LR-N16-0148

Hope Creek Generating Station
Renewed Facility Operating License No. NPF-57
NRC Docket No. 50-354

Subject: Supplemental Information Regarding Hope Creek Generating Station's Request for Relaxation from the Hardened Containment Vent Release Point Height Requirement of NRC Order EA-13-109

**Supplemental Information Regarding Hope Creek Generating Station's Request
for Relaxation from the Hardened Containment Vent Release Point Height
Requirement of NRC Order EA-13-109**

Figure 1: Option 1, 283'-5" HCVS Modifications

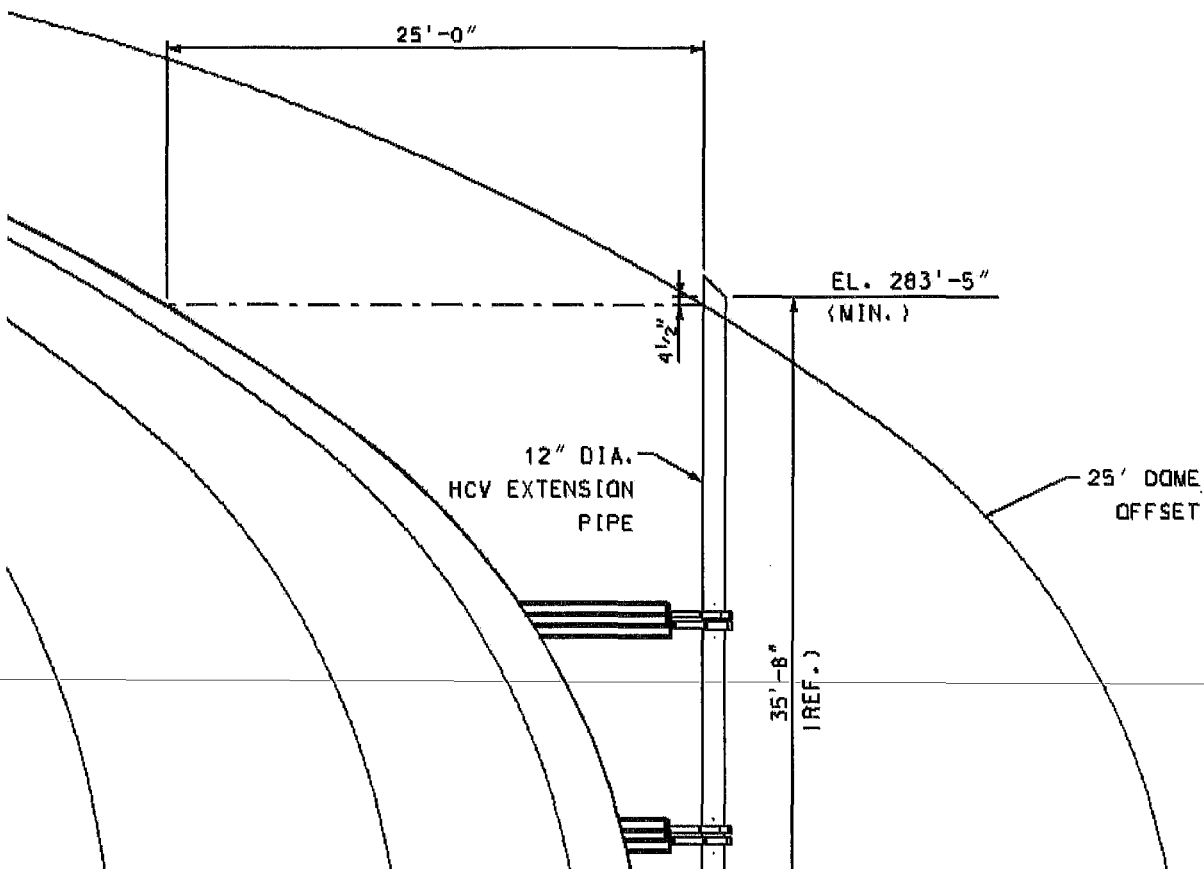
4.1 Option 1 Extend the current HCVS to elevation 283'-5" via straight vertical extension

This option would not achieve verbatim compliance with the vent height requirement of NRC Order EA-13-109, and it would still require NRC relaxation. This option meets the 25'-0" lateral separation distance recommended by HCVS-FAQ-04 in Appendix J to NEI 13-02, Revision 1.

This option has been proven to have the capability to meet the 1% RCTP decay heat removal requirement. However, it is not a preferred option because it would result in negligible benefit in atmospheric dispersion and would not result in full compliance with NRC Order EA-13-109.

Extending the vent height vertically from elevation 250' to elevation 283'-5" would involve extensive modifications in regards to pipe supports and anchors into the Reactor Building, as shown in Figure 1. This option also involves installation challenges and personnel safety considerations due to working at heights and heavy load handling.
